Staff Report

Project Name: 5556 S Sycamore Sketch Plan

Case Number: SP18-0011

Applicant Request: Overturn staff's denial of sketch plan

Figure 2: Proposed Sketch Plan With Highlighted Change Locations (West and North Elevations)

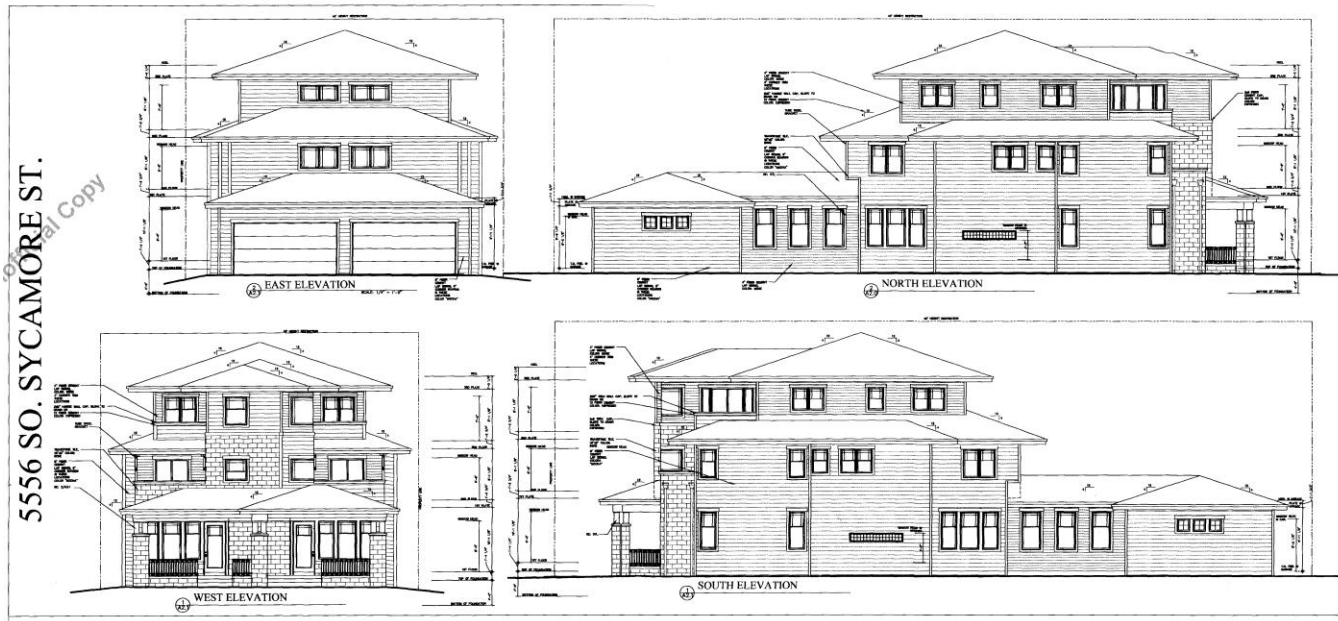
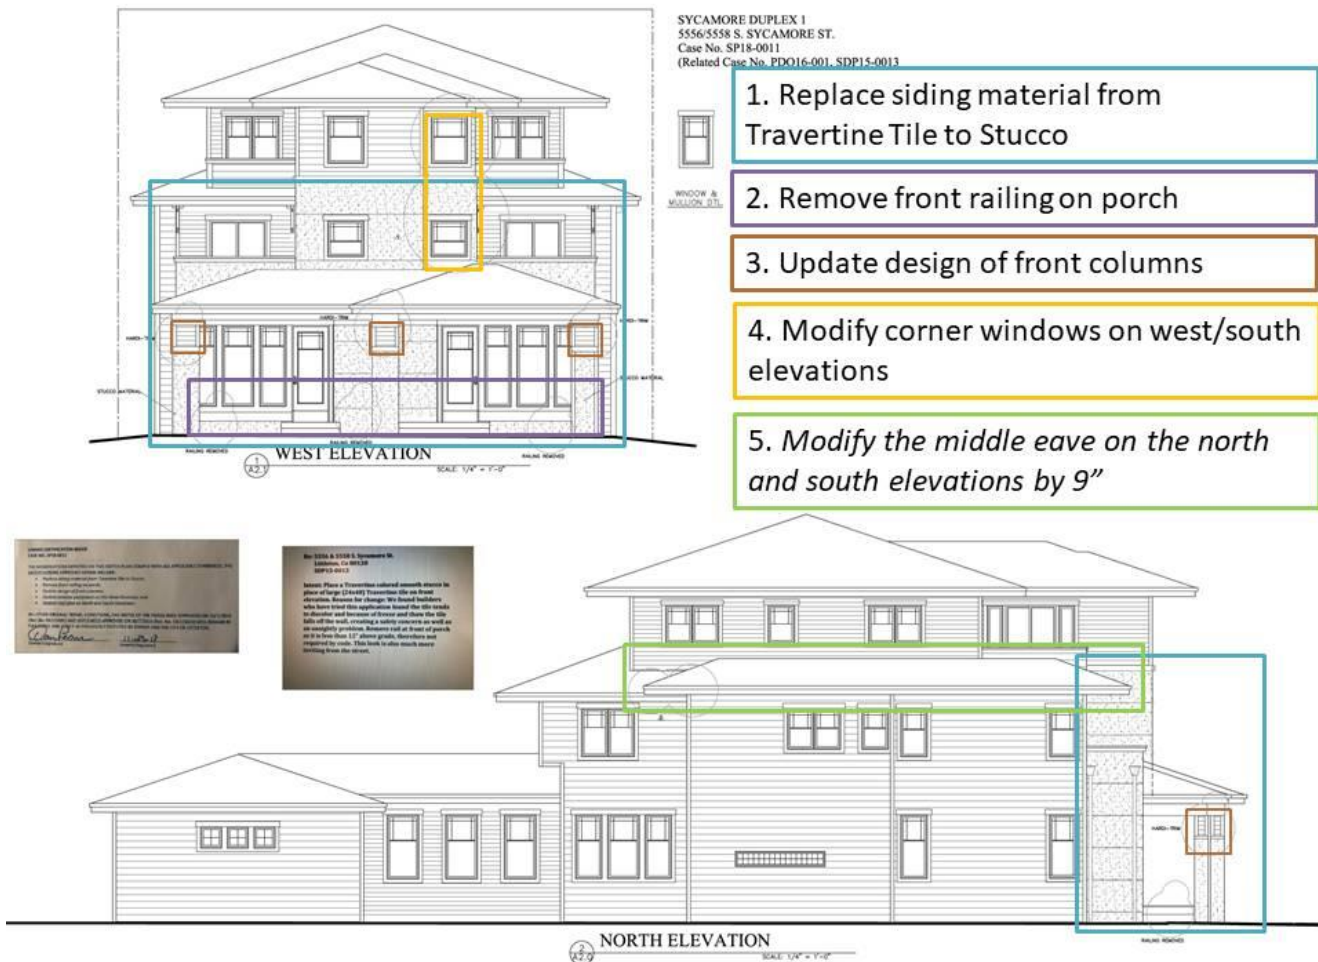
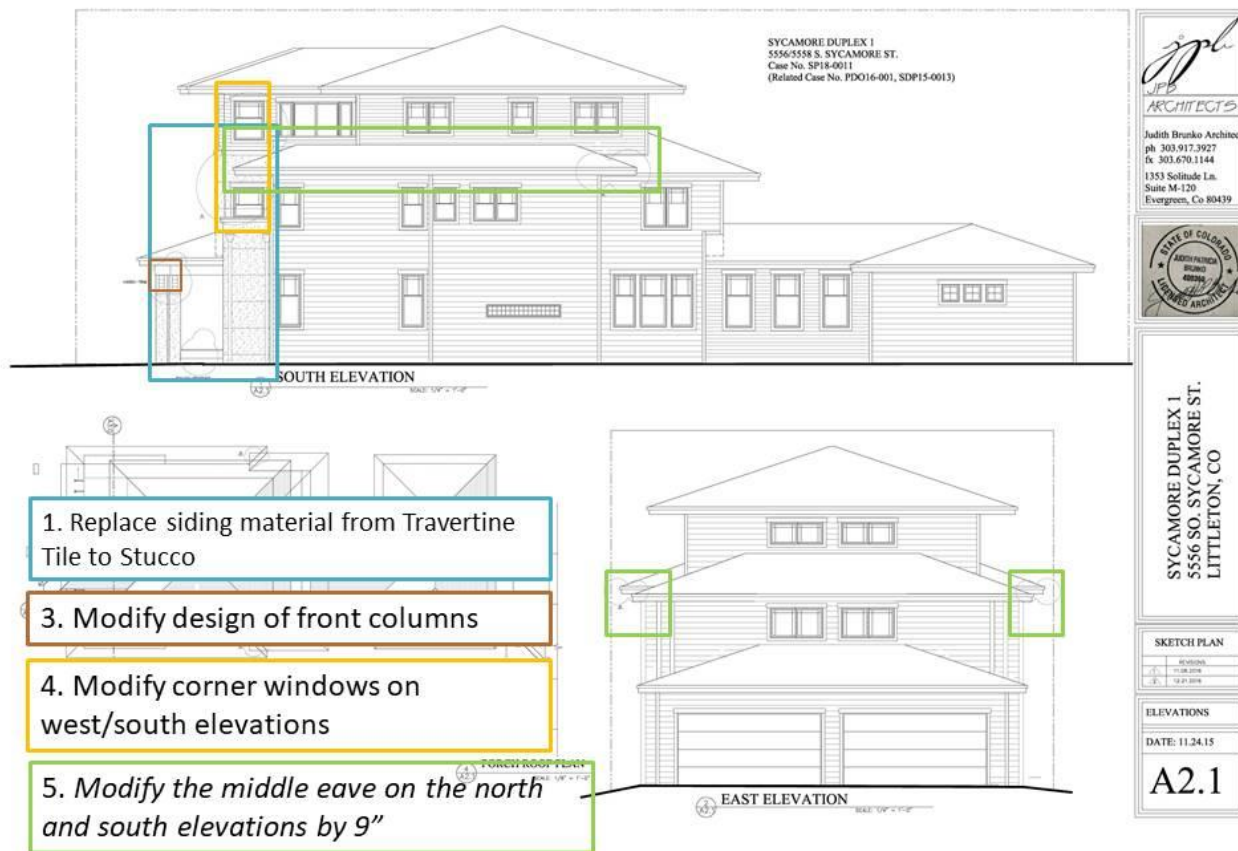
On November 11, 2018 the applicant submitted a sketch plan for “as-built” material and building detail modifications to the approved PDO/SDP/building permit. The five modifications are:

1. *Replace siding material from travertine tile to stucco*
2. *Remove front railing on porch*
3. *Modify design of front columns*
4. *Replace corner windows on the west/south elevations with individual windows on each elevation*
5. *Increase the height of the middle eave line on the north and south elevations by nine inches (does not affect overall building height).*

Figure 1 is the approved PDO/SDP/building permit elevations. Figures 2-3 illustrate the location of the changes between the proposed sketch plan and the approved PDO/SDP/building permit. The criteria and staff analysis section addresses each of the five changes in detail.

Figure 5

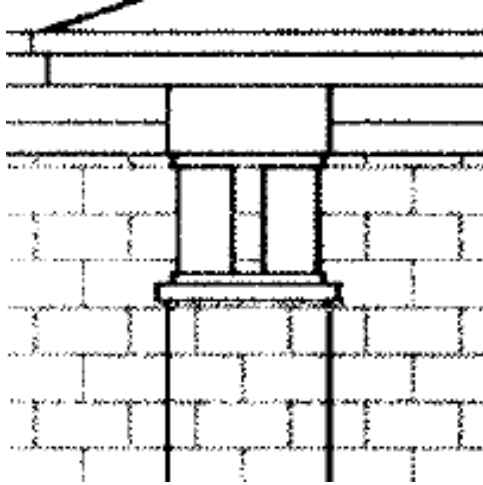
Figure 5 (on the following page) illustrates the difference in column design on the approved PDO/SDP/building permit plans and the constructed column.

The approved plans show the top of the tile-clad porch columns with double-pilar detail, which has some negative space where travertine tile can be seen in the backround. The as-built columns in the proposed sketch plan show a solid cap to the stucco-clad porch columns with a lap-siding detail. During the public hearing, the quality of the building face was noted; however, the design of the columns was not specifically discussed. Applicant did not address this change in the letter of intent.

Figure 6

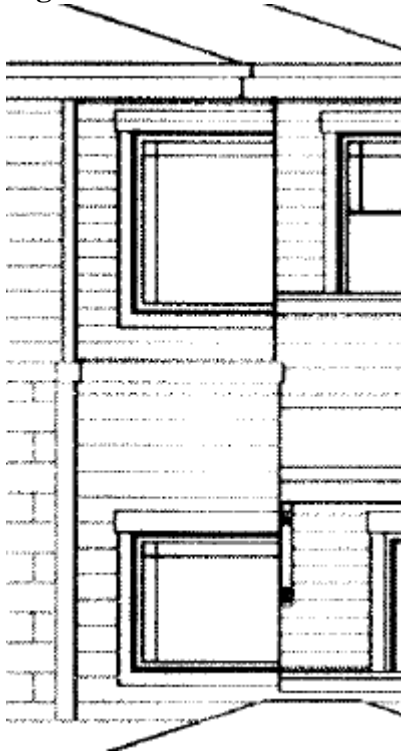
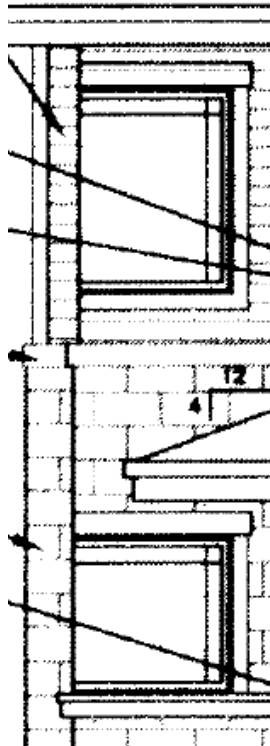
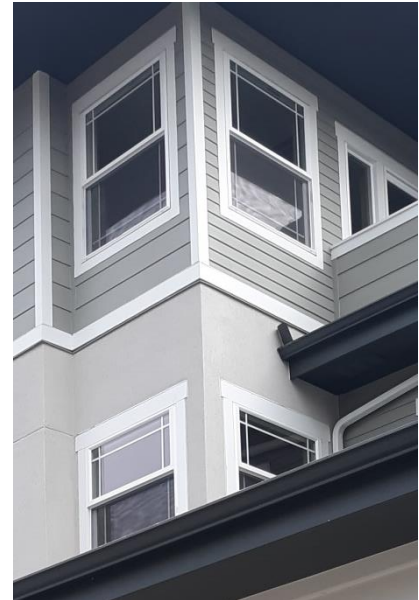
The approved PDO/SDP/building permit plans show two “corner windows” on the second floor that wrap around the 90-degree corner on the west and south elevations. Figure 6 (on the following page) illustrates the difference in window placement on the approved PDO/SDP/building permit plans and the as-built construction with four individual windows.

The window design was not specifically discussed during the public hearing. The Applicant did not address this minor change in the letter of intent. This alteration is relatively minor in nature and may have been eligible for approval with the building permit.

Figure 7

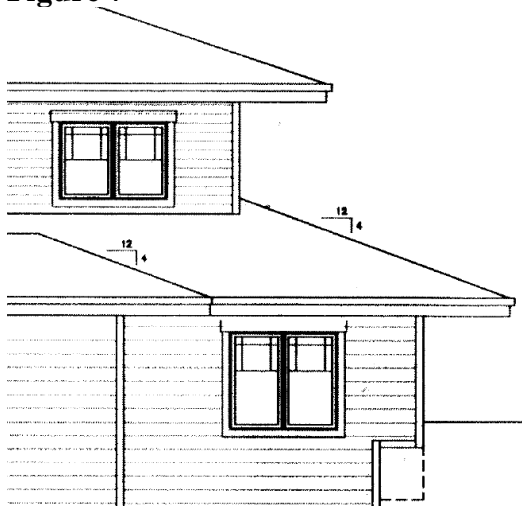
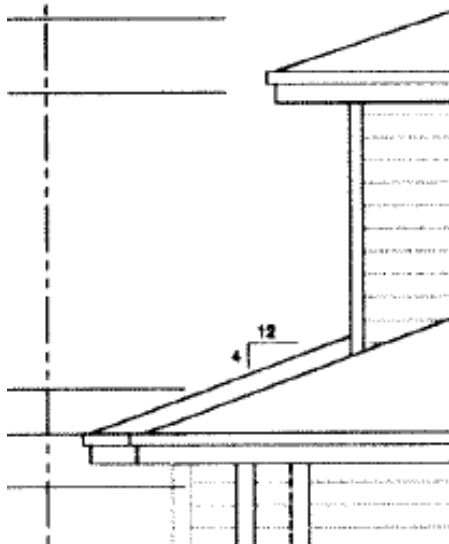
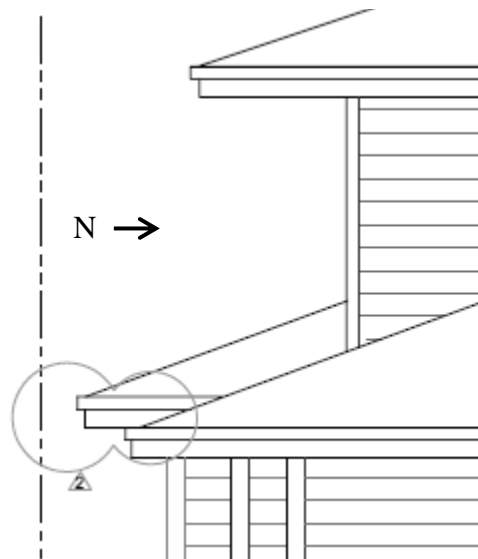
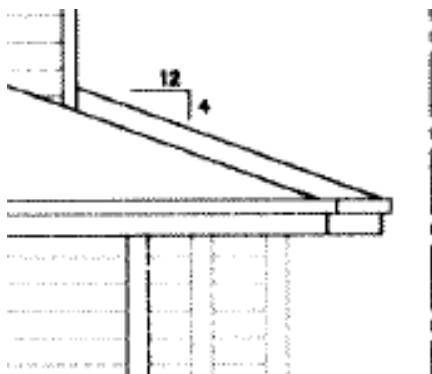
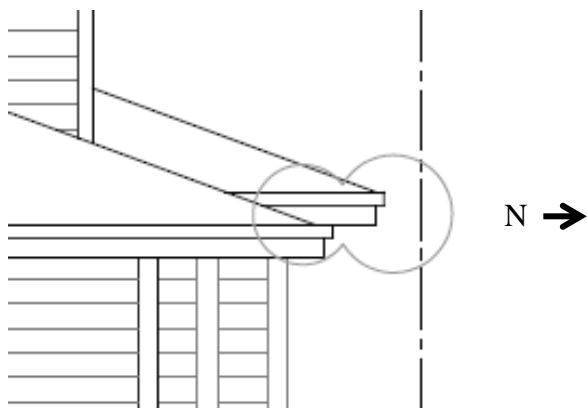
The roof alterations identified on the proposed sketch plan illustrate how the height of the middle eave lines on the north and south elevations were increased nine inches. The applicant did not address this minor change in the letter of intent. Figure 7 (on the following page) illustrates the modification, but the change is not easy to photograph or notice from the ground view.

The modification made during construction was not readily apparent from the original site inspection. After being made aware of the change, staff was only able to minimally observe the modification from the alley. This type of alteration would normally be approved through the building permit process, especially since it does not affect overall height or setback.
